Technical Service Information

FORD AX4S **1-2 NEUTRAL 1999 & UP MODELS**

Figure 1

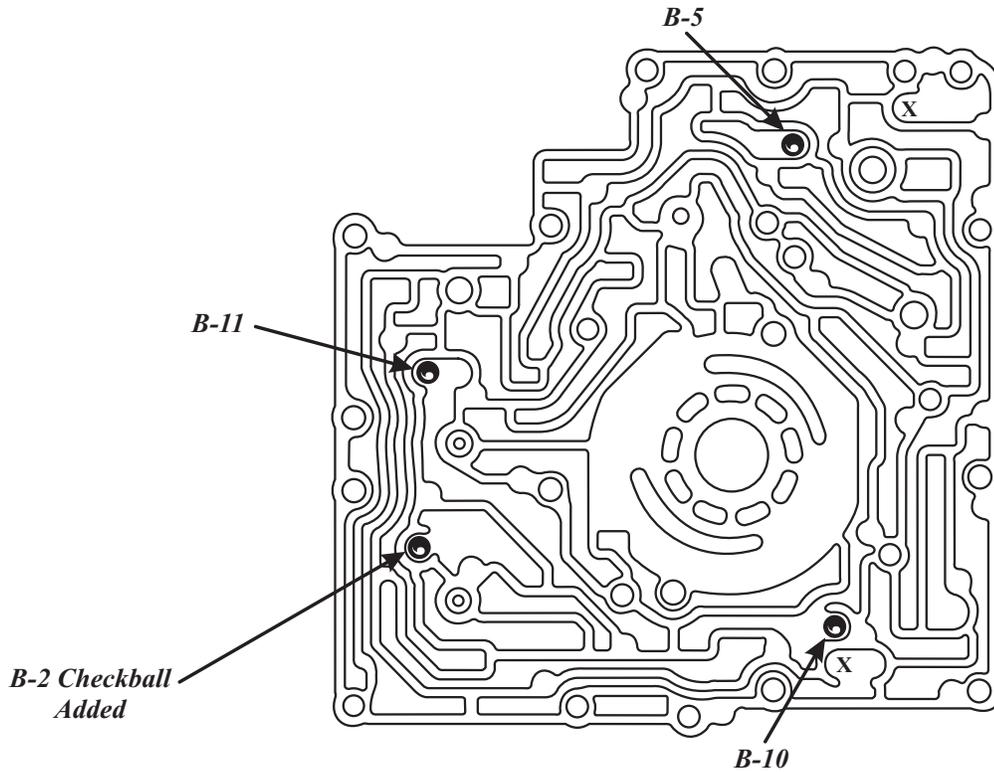
COMPLAINT: 1999 and Up Ford vehicles equipped with the AX4S transaxle may exhibit a 1-2 neutral condition after overhaul. Upon valve body inspection, the 1-2 Capacity Modulator Valve is not sticking.

CAUSE: The cause may be, during overhaul, the pump had to be replaced, because of typical pump shaft bearing and rotor failure, and a replacement pump body with a 98 and earlier spacer plate was used. The 1999 and up pump plate requires 3 check balls, and when the B5 check ball is left out when using the previous design spacer plate, L12 pressure will be lost at the manual valve, thru the Reverse circuit.

CORRECTION: Refer to Figure 1 to identify the previous design Pump body and Pump spacer plate, and Refer to Figure 2 to identify the 1999 and Up design Pump body and Pump Spacer plate and ensure that the correct plate and checkball locations are used.
